John R. Kasich, Governor
Mary Taylor, Lt. Governor
Scott J. Nally, Director
October 31, 2012

RE: SUM-SEIBERLING PHS 2
3GC05686*AG
STORMWATER
SUMMIT COUNTY

Ray Kinney
Site Manager
Sitetech
35700 East Royalton Road
Grafton, Ohio 44044

10/29/2012: Exposed waste contacting storm water producing leachate (west side)

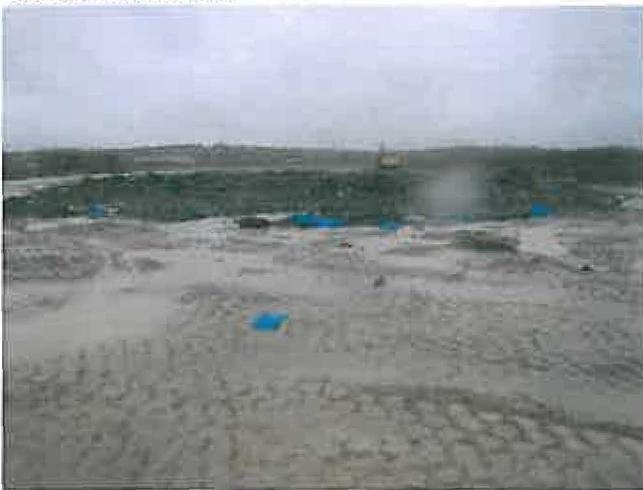
- 2) There is exposed relocated waste on top of the landfill. At several points on the east, south and west side of the landfill, storm water that has contacted solid waste was running down the cover material and entering the storm drainage system. This is leachate. The City of Akron representatives, their consultants, your consultants and yourself were all informed that any water contacting solid waste is considered to be leachate. Leachate entering the storm water system, causes all water it mixes with to be leachate. The General Construction Stormwater NPDES Permit 3GC05686*AG does not authorize the discharge of leachate to waters of the state. **Discharging leachate and/or leachate contaminated storm water would be a violation of the permit and a violation of Ohio Revised Code 6111.04 and 6111.07.** All leachate must be collected and hauled to a properly licensed treatment facility.

- 1) To date, the water collected in detention area 3 and the sedimentation pond is considered to be leachate. It will need to be pumped and hauled to a properly licensed treatment facility. Please state when this will occur and to what treatment facility it is disposed. Also, state whether or not leachate or leachate contaminated storm water has been discharged from the site to date.
- 2) State whether or not detention area 1 is located over solid waste and if it was constructed in accordance with the approved SWPPP.
- 3) Water collected behind the pilings isolating Haley's Ditch must be pumped thru the filter bag. Please acknowledge.
